Re: APP/26/00154 At 154 London Road, Waterlooville, PO7 5SR

Detailed application for the erection of 111 dwellings at the former Goodwillies Timber Yard

Thank you for your consultation on the above full planning application. To support this planning application the applicant has submitted a Transport Assessment (TA) Rev 02 dated February 2026 and supporting drawings which the Highway Authority have reviewed and wish to make the following comments.

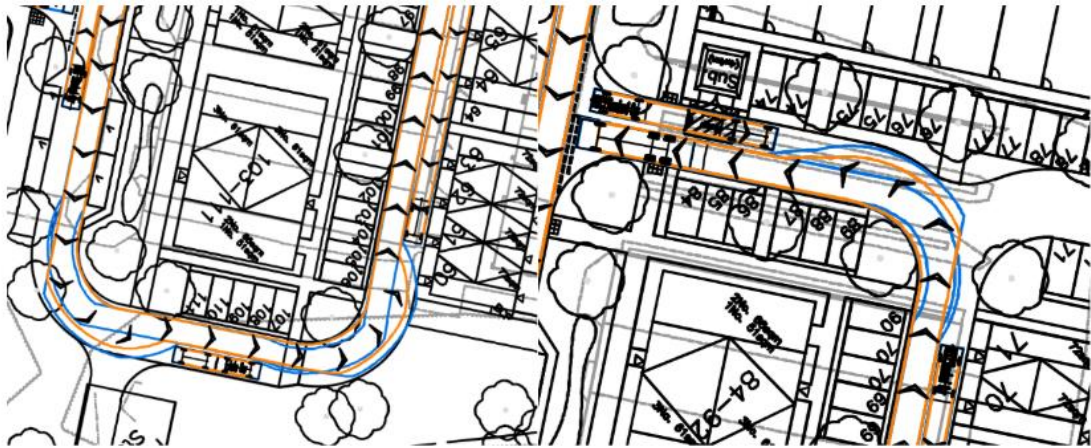
The applicant has provided swept path analysis for an 11.20m 'super large' refuse vehicle and fire tender within drawings 2024-6687-005 Rev A and 2024-6687-005 Rev A respectively. The dimensions of the vehicles align with that set out within HCC TG2 however the tracking speeds have not been confirmed. This should be revised and undertaken at 10mph at junctions and undertaken in line with the proposed design speed internally. Notwithstanding this the Highway Authority have reviewed the tracking drawings and have the following comments to make.

The refuse tracking identifies where there are opportunities to pass a large car throughout the internal road network. At bends where these vehicles cannot pass suitable forward visibility needs to be demonstrated. It does not appear that these vehicles will be able to pass within the forward visibility envelopes demonstrated and these should be overlaid on the tracking plan for ease. Localised widening around bends may be required to ease the alignment and tracking demonstrated.
